From: Mauricio Alvarez <malvarez@riversidetransit.com>
Sent: Thursday, February 23, 2023 9:21 AM
To: Ramaiya, Jarrett <jramaiya@MurrietaCA.gov>
Subject: Terraces Apartment Project

Subject: Notice of Availability and Intent to Adopt a Mitigated Negative Declaration

Project Description: DP 2022-2518, TPM38373, PH2022-2614, 899 apartment units on a 40.03 acre site, consisting of eleven (11), four story apartment buildings and twelve (12) two-story carriage unit buildings

Development Services Department (DS)
DESIGN CONDITIONS (DC)
 [Formerly: Plan Of Service]

**Exhibit(s) of DC Facilities:
existing and proposed facilities**

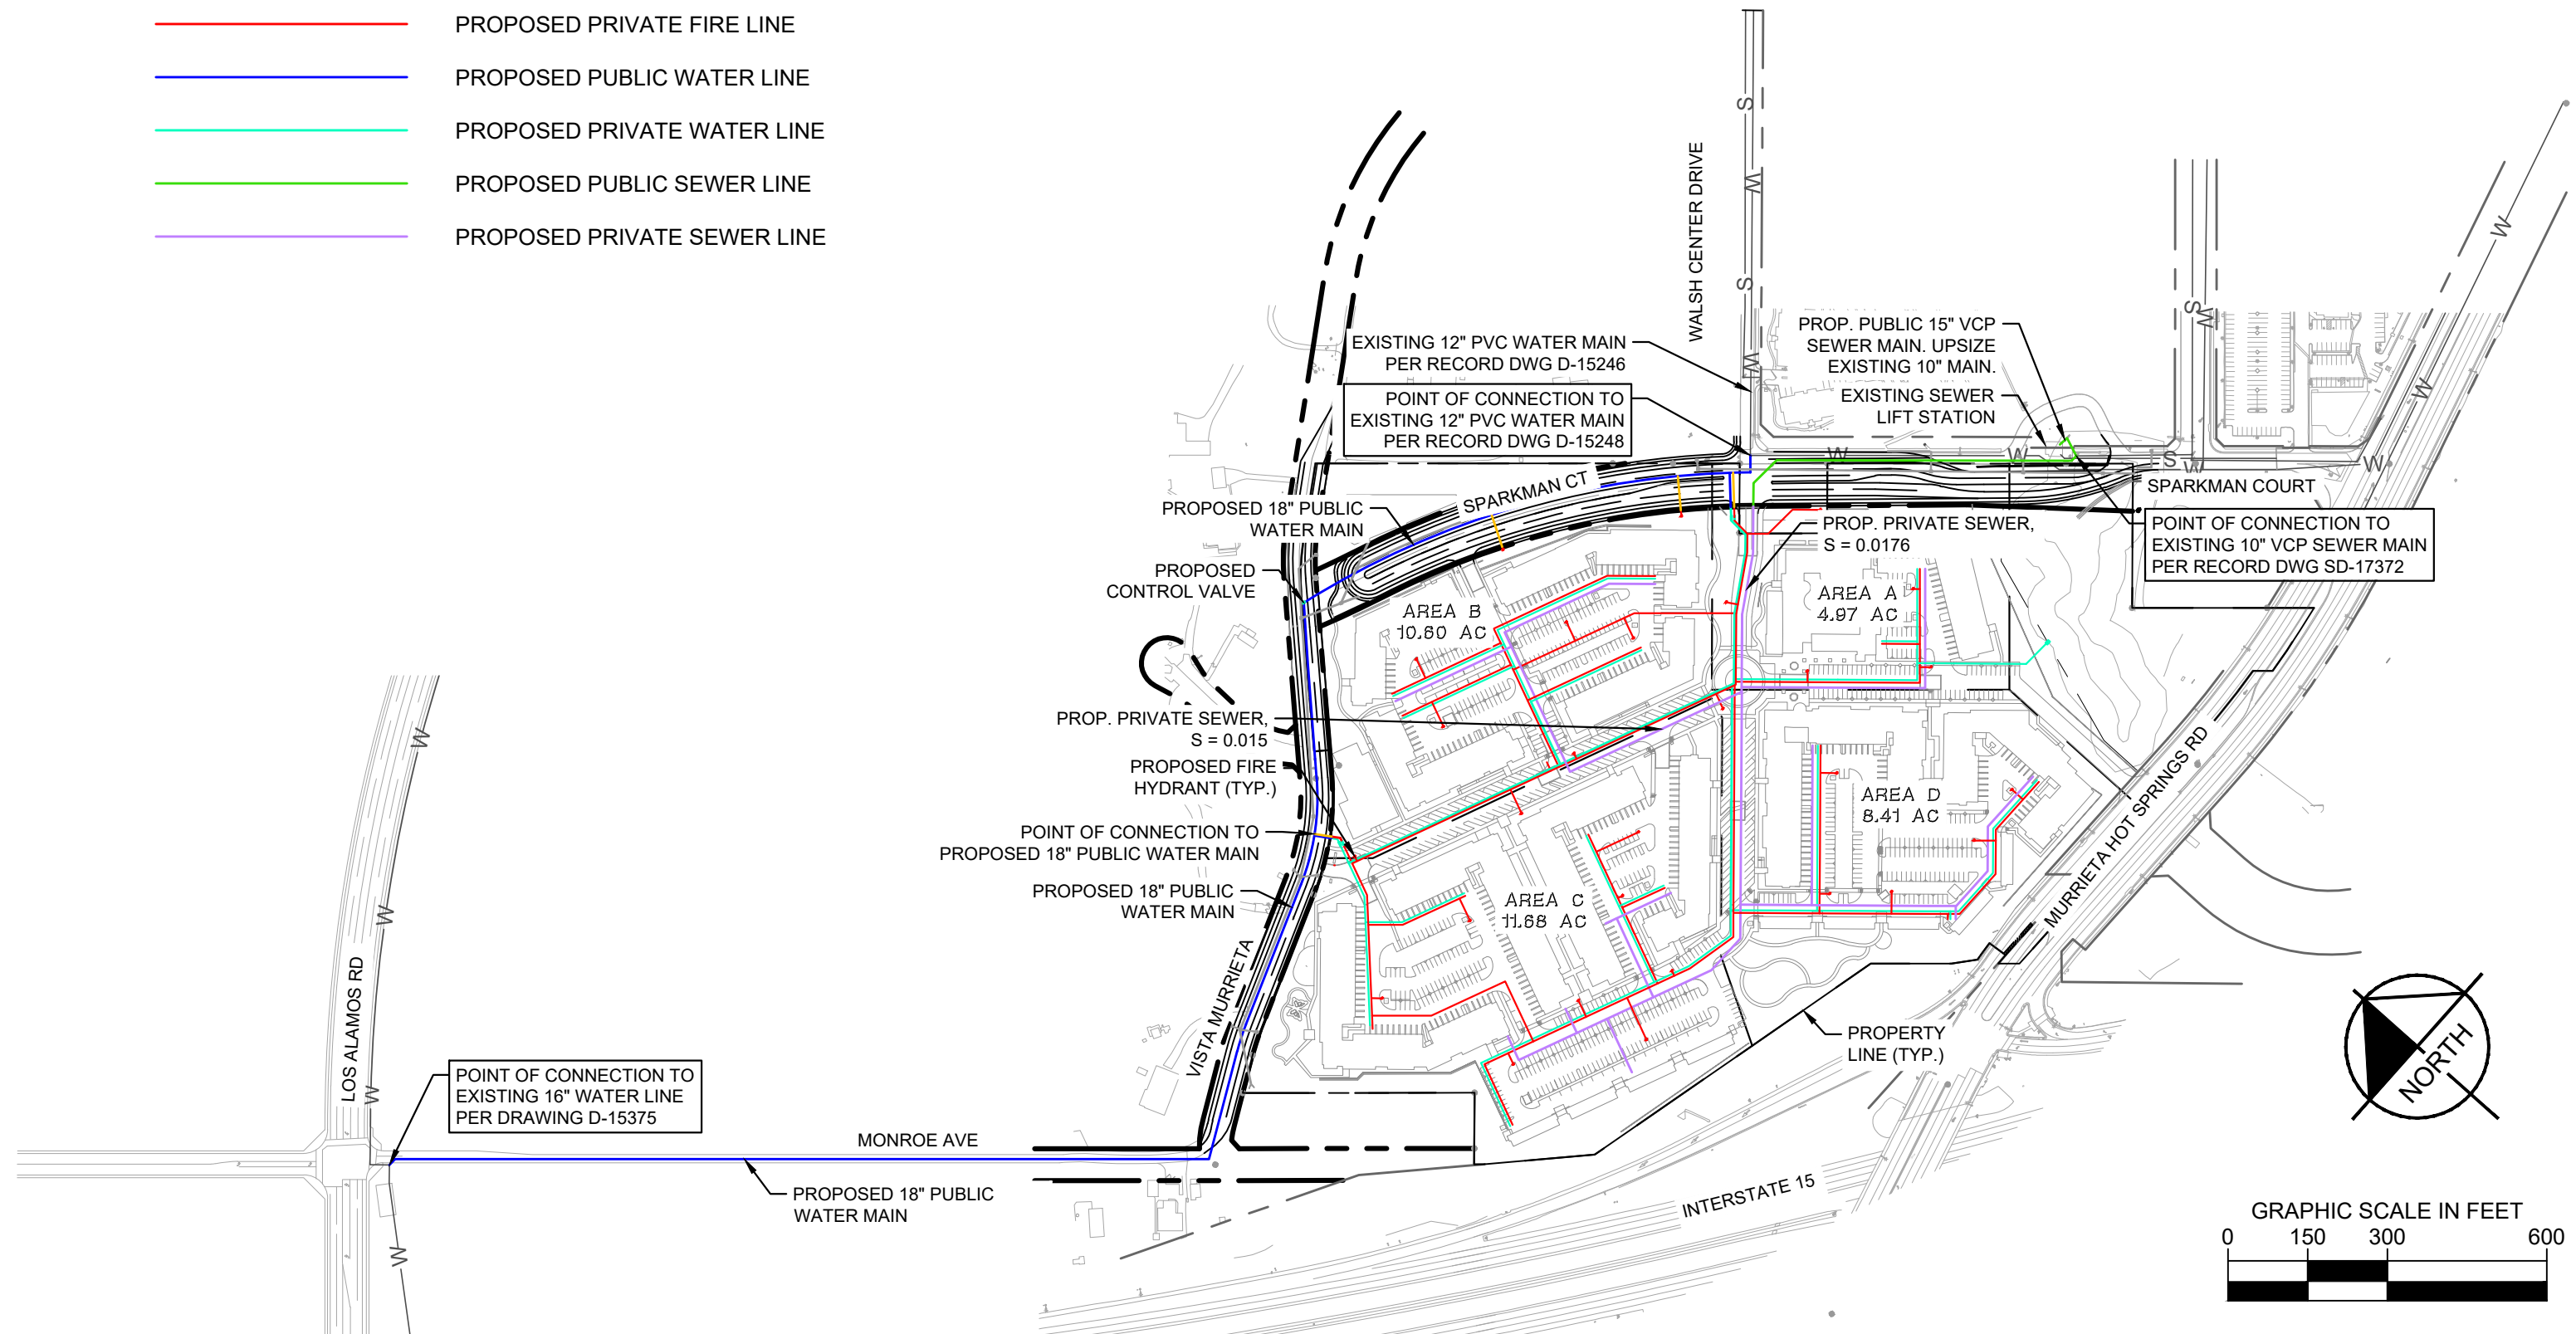
XIII. SPECIAL CONDITIONS: For Conditions 1 and 2, please select one of the choices from the Drop-Down List - For all others, do NOT delete the ones that do not apply, instead, cross them out.

1-	At the time this DC was processed, final Conditions Of Approval (COAs) were not available: Therefore, the COAs shall be provided as part of the first Plan Check submittal
2-	Per attached confirmation by the sponsor/developer waiving his/her right for facility oversizing reimbursement from EMWD, the project shall not receive consideration for oversizing reimbursement.
3-	It is the applicant's responsibility to provide any updates or revisions to the Project COA during the development, or after the approval, of the DC. The DC shall be revised and updated as needed, including updating the Fire Flow test if the requirements are different from the original test: Failure to provide timely COA updates or revisions may result in potential additional facility requirements and/or delays in processing the project during subsequent phases (such as Plan Check or Agreement phases).
4-	(Only for Residential lots) Plan checker shall utilize the attached service-pressure table(s) to determine pressure conditions for each lot, and cause the recordation of High or Low pressure conditions if applicable: Low Pressure Agreement is required for lot pressures <50 psi; High Pressure Agreement is required for lot pressures >80 psi; and Lots with pressures <50 psi shall receive a minimum of 1.5" service laterals .
